**BEFORE THE INDEPENDENT HEARING PANEL APPOINTED BY THE
QUEENSTOWN LAKES DISTRICT COUNCIL**

**JOINT STATEMENT OF URBAN DESIGN & TRANSPORT EXPERTS IN
RELATION TO TE PŪTAHI LADIES MILE PLAN VARIATION**

DATED 24 NOVEMBER 2023

Ninth Line – Markham, Toronto

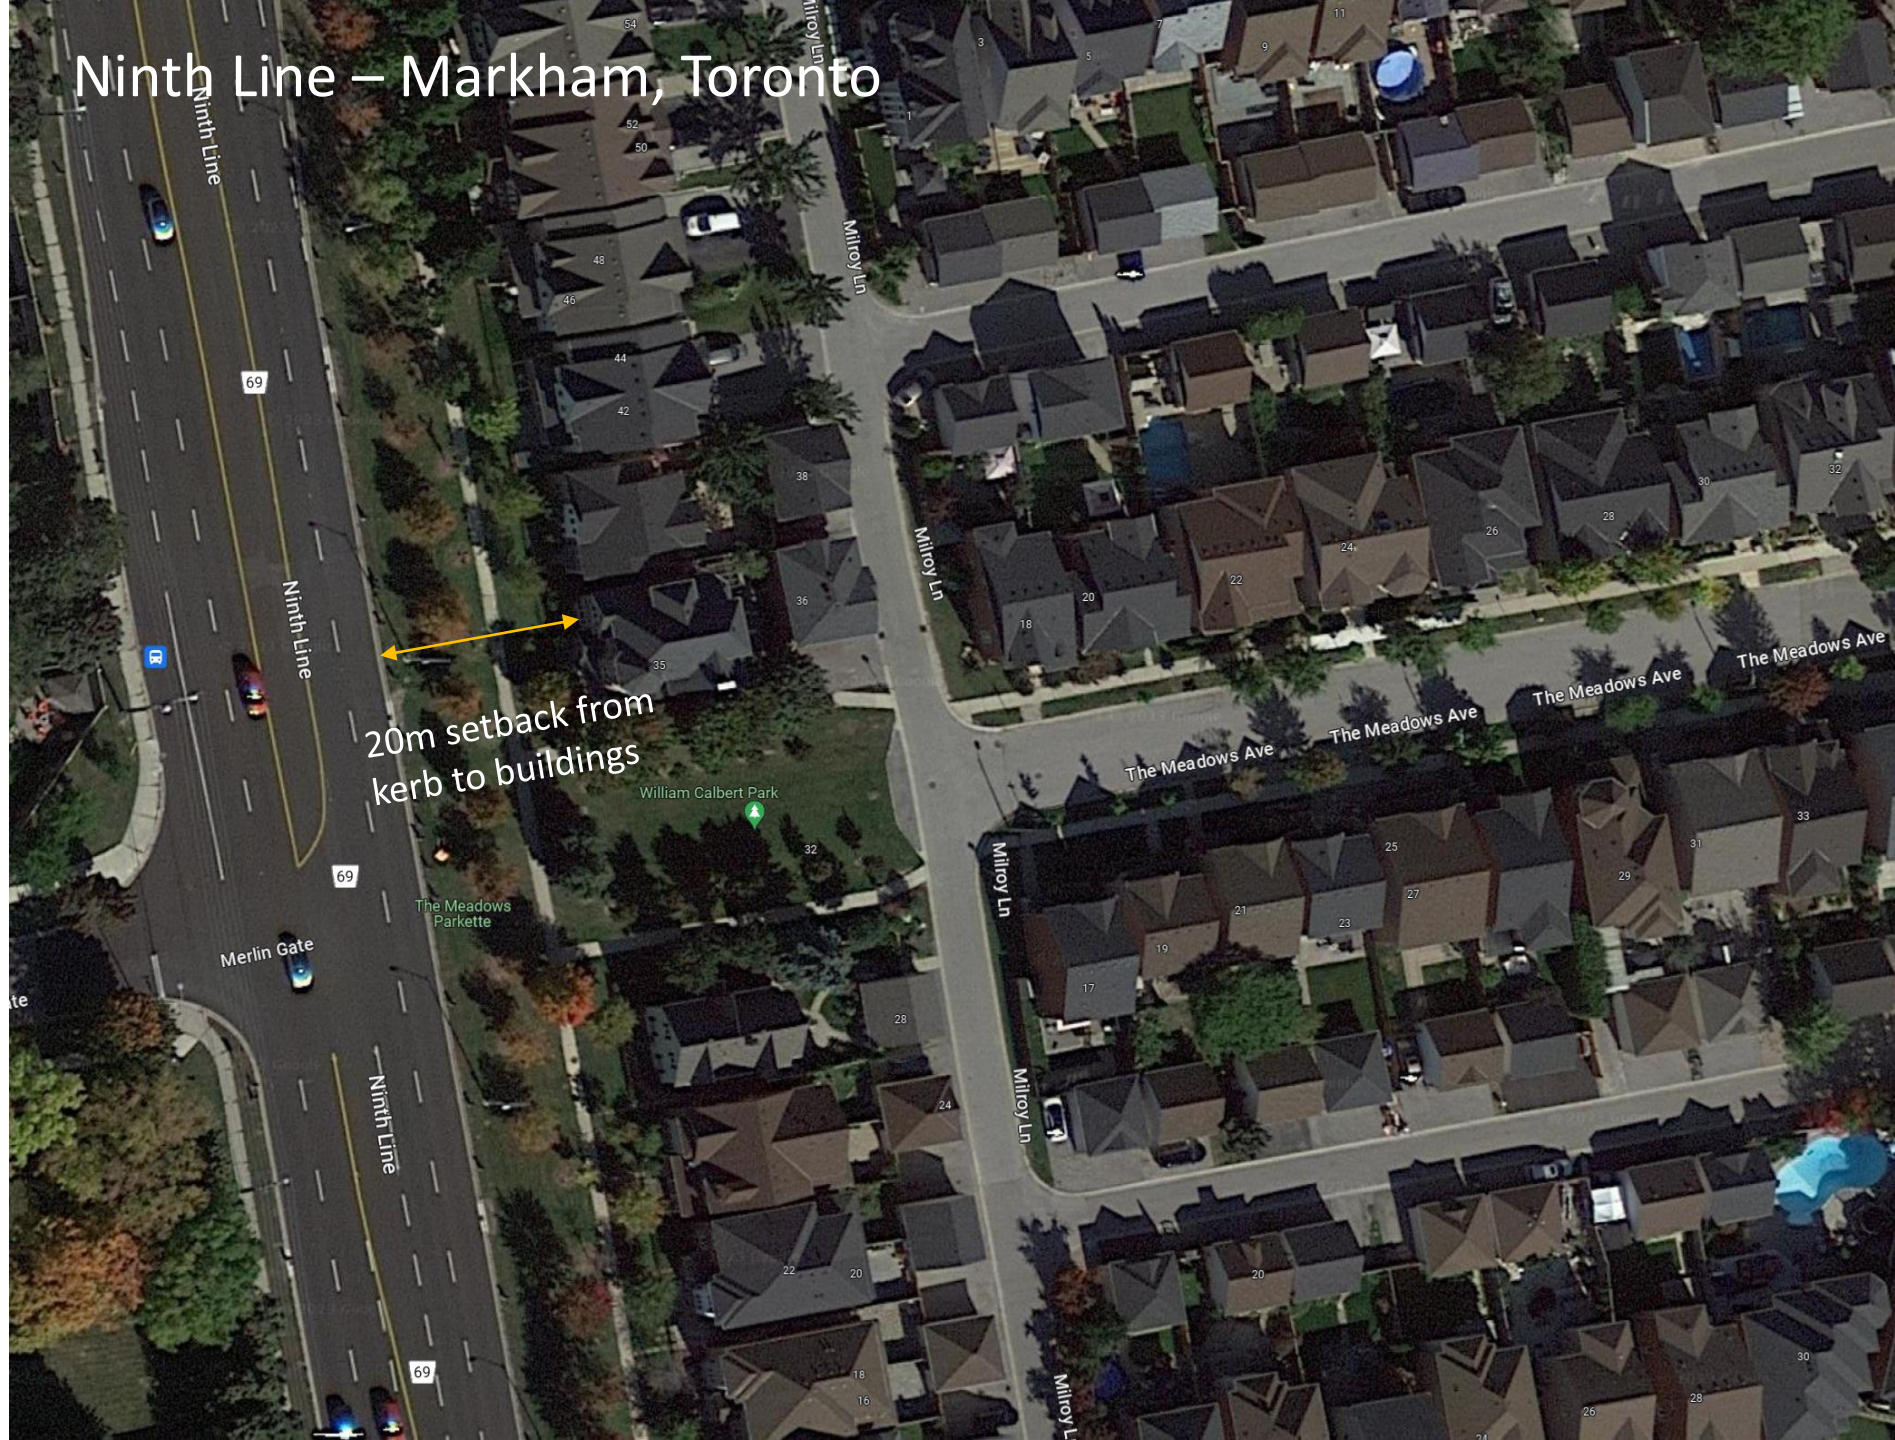
| | <p>balance between recognising Ara Tawhito (traditional trails) / stormwater treatment of SH6 and rural pastoral heritage / retention of the existing trees on the south side.</p> | <p>width provided for large, 'Feature Trees' on the northern side. Council UD experts provided precedents from Toronto, Canada and Waihi SH2 (Attachment D).</p> <p>Mr Smith indicated that there is likely be a loss of continuity in the landscape treatments along SH6, due to the large intersection footprints. He was concerned about the visual screening effect of vegetation in obscuring an urban environment (i.e. friction) and was further concerned about the impact of large trees on shading (i.e. ice formation) and debris falling from trees onto the carriageway.</p> <p>Mr Harland noted that the slower speed urban nature of the corridor is not dissimilar to many towns and that management of leaf litter is normal practice in urban environments. Mr Harland showed an example of Waihi Beach where mature trees had clear views underneath their canopy to the 'urban' edges with circa 60m legal corridor and 70m building to building. Use of deciduous trees could also reduce frost related risks. Mr Church queried who the large scale amenity planting was intended for, SH6 or TPLM users. He noted that larger trees could have an impact on residents' likely expectation of views of the natural landscape context (e.g. Remarkables) from within the TPLM Variation Area. Mr Weir considered they would overly 'domesticate' buildings behind them and would create further visual severance between north and south communities. Both were seeking more relativity between existing trees to the south.</p> |
